Access Compliance Report

Public Rights-of-Way

(Curb Ramps)

Intersection ID: 43374	Main Street: COOPER'S RIDGE LN	Cross Street: BERNBROOKE_SHADOW LN	Location:	N
ADA ID: F4D94BE992F0	Ramp Type: BlendTrans1	Initial Pass/Fail: Fail	Overall Compliance: No	Severity Score: 10
Codes/Mitigation Info/Possible Solution		Field Measurements/Component Compliance

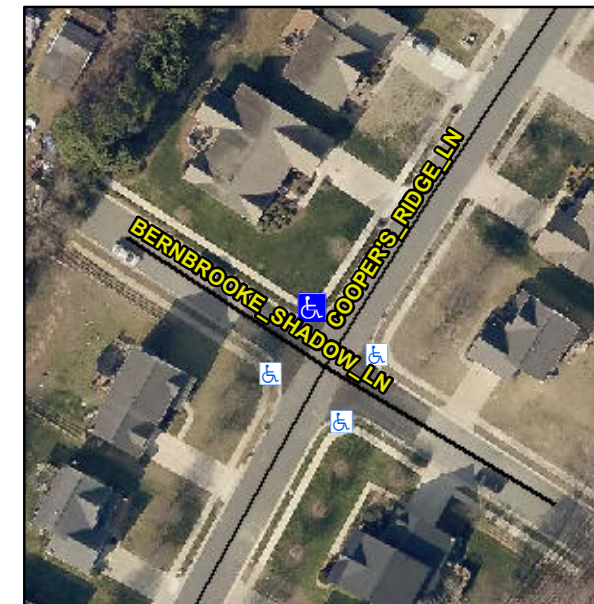
Not Found, R304.5.1, R304.5.3

Compliance	Description	Data	Compliance	Description	Data
N/A	Ramp Length (in)	49.5	Yes	BlendTrans Slope (%)	3.2
No	Ramp Width (in)	40.0	No	BlendTrans XSlope (%)	3.0
N/A	Flare Type LT	N/A	N/A	Flare Type RT	N/A
N/A	Flare Slope LT (%)	N/A	N/A	Flare Slope RT (%)	N/A
N/A	Flare Traversable LT?	N/A	N/A	Flare Traversable RT?	N/A
N/A	Landing Length (in)	N/A	N/A	DWS Provided?	N/A
N/A	Landing Width (in)	N/A	N/A	DWS Contrast?	N/A
N/A	Landing Slope (%)	N/A	N/A	DWS Length (in)	N/A
N/A	Landing X Slope (%)	N/A	N/A	DWS Full Width?	N/A
N/A	Landing Curb? (Y/N)	N/A	N/A	DWS Offset (in)	N/A
N/A	Shared Landing?	N/A			
N/A	Gutter Ponding?	N/A	N/A	Gutter Slope (%)	N/A
N/A	Gutter Lip Ht (in)	3.0	N/A	Gutter X Slope (%)	N/A
N/A	Painted X Walk1?	No	N/A	Painted X Walk2?	No
	X Walk 1 Direction	To SW		X Walk 2 Direction	To SE
	X Walk 1 Width (in)	N/A		X Walk 2 Width (in)	N/A
	X Walk 1 Slope (%)	0.1		X Walk 2 Slope (%)	0.8
	X Walk 1 X Slope (%)	0.4		X Walk 2 X Slope (%)	1.3

N/A	Ramp inside XWalk1?	N/A	N/A	Ramp inside XWalk2?	N/A
	Road Slope (%)	1.0		Clear Space?	N/A
	Road X Slope (%)	1.4	N/A	Clear Space to XWalk (in)	N/A
N/A	Any Obstructions?	N/A	N/A	Storm Grate/Utility Hazard?	N/A
	Obstruction Type			Storm Grate/Utility Type	
		N/A			N/A
			Yes	Surface Condition? (G/P)	Good
			No	Curb Slope (%)	17.0

Remove & Replace Curb Ramp With Two New Directional Ramps or Equivalent.
